10/533,020

Office Action Summary	Application No. 10/533,020	Applicant(s) GLASSE ET AL.	
	Examiner EARL N. TAYLOR	Art Unit 2818

DETAILED ACTION

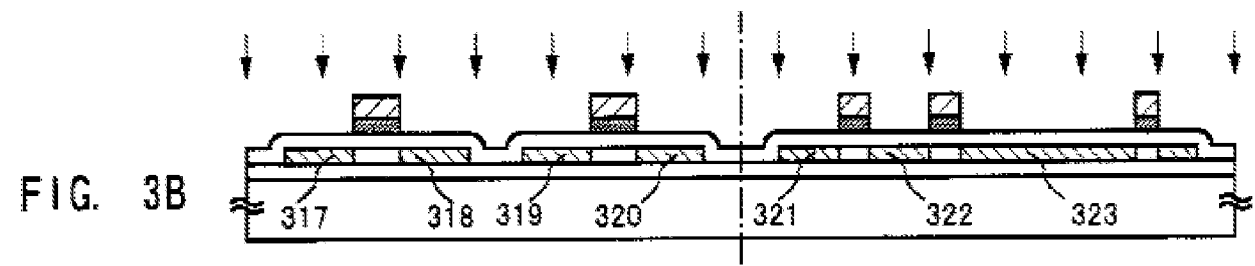
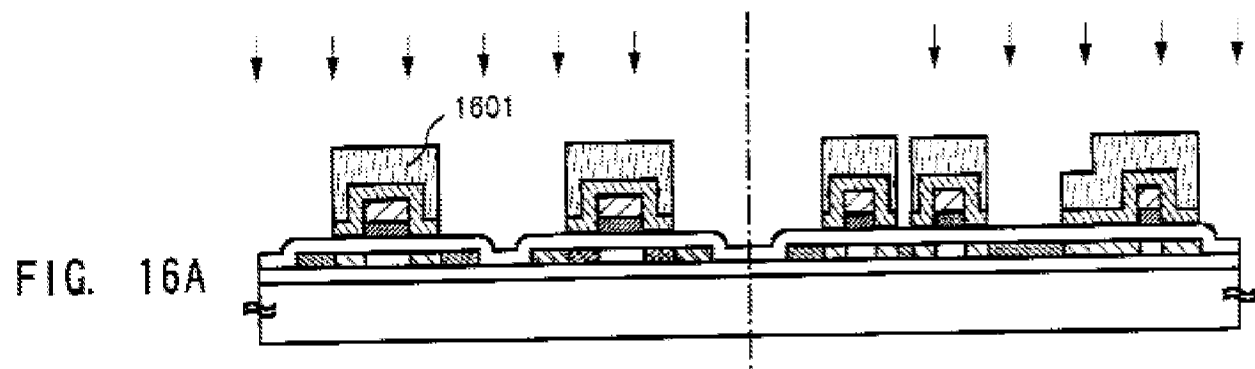
Referring to Claim 8, Nakajima teaches, in Fig. 3A-3C and 16A-16D for example, a method of fabricating a polycrystalline silicon channel TFT with a gate overlying the channel, having an upstanding gate side wall, the method comprising the steps of:

(a) providing a gate (307 and 312) separated from a polycrystalline silicon layer (303) by an insulating layer (306) (Fig. 3A);

(b) implanting a dopant (317 and 318) into the polycrystalline silicon layer (303) using the gate (307 and 312) as a mask (Fig. 3B);

(c) forming a spacer (1603; Fig. 16A-16D) after step (b) adjacent to the gate (307 and 312) that comprises a conductive region which overlies the polycrystalline silicon layer (303) and extends along the gate (307 and 312) side wall, comprising depositing a layer of conductive material (second gate) over the polycrystalline silicon layer (303) and the gate (307 and 312), and selectively etching the deposited layer of conductive material (second gate) to form the spacer (1603) with a first portion overlying the polycrystalline silicon layer (303) and a second portion extending along on the side wall of the gate (307 and 312), wherein the layer of conductive material (second gate) has a thickness less than that of the gate (307 and 312); and

(d) implanting a dopant into the polycrystalline silicon layer (303) using the gate (307 and 312) and the spacer (second gate) as a mask to form a source or drain region, such that the spacer (second gate) overlies an LDD region in the polycrystalline silicon layer (303) between the source or drain region and the channel (Col. 9, Line 8 to Col. 11, Line 9 and Col. 17, Lines 28-64).

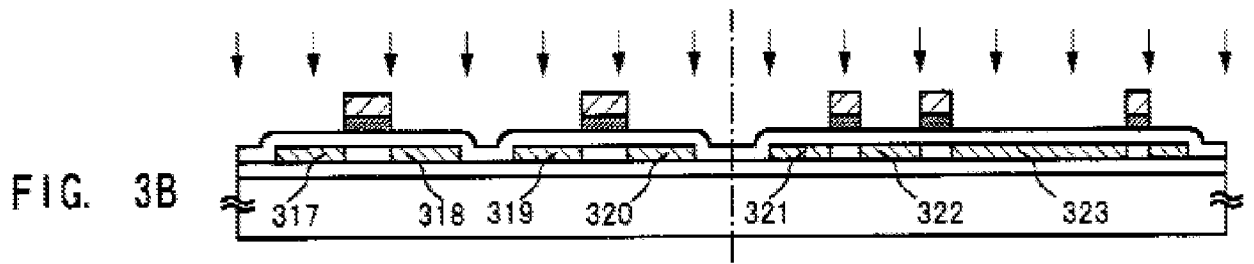
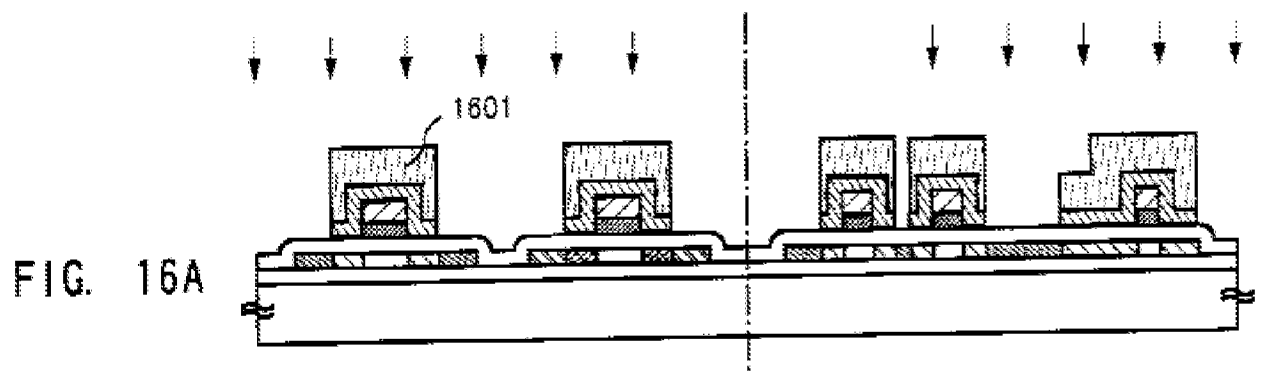
Referring to Claim 13, Nakajima teaches a method of fabricating a polycrystalline silicon channel TFT with a gate overlying the channel, having an upstanding gate side wall, the method comprising the steps of:

(a) providing a gate (307 and 312) separated from a polycrystalline silicon layer (303) by an insulating layer (306);

(b) implanting a dopant into the polycrystalline silicon layer (303) using the gate (307 and 312) as a mask;

(c) forming a spacer layer (1603; Fig. 16D) after step (b) adjacent to the gate (307 and 312) that comprises a conductive region which overlies the polycrystalline

silicon layer (303) and extends along the gate (307 and 312) side wall, comprising depositing a layer of conductive material (second gate) over the polycrystalline silicon layer (303) and the gate (307 and 312), and selectively etching the deposited layer of conductive material (second gate) to form the spacer (1603) with a first portion overlying the polycrystalline silicon layer (303) and a second portion extending along on the side wall of the gate (307 and 312), wherein the selective etching of the conductive layer (second gate) is carried out by forming a fillet (1601) over the first portion thereof, and selectively etching the conductive layer (1603) where not protected by the fillet (1601); and

(d) implanting a dopant into the polycrystalline silicon layer (303) using the gate (307 and 312) and the spacer (1603) as a mask to form a source or drain region, such that the spacer (1603) overlies an LDD region in the polycrystalline silicon layer (303) between the source or drain region and the channel (Col. 9, Line 8 to Col. 11, Line 9 and Col. 17, Lines 28-64).
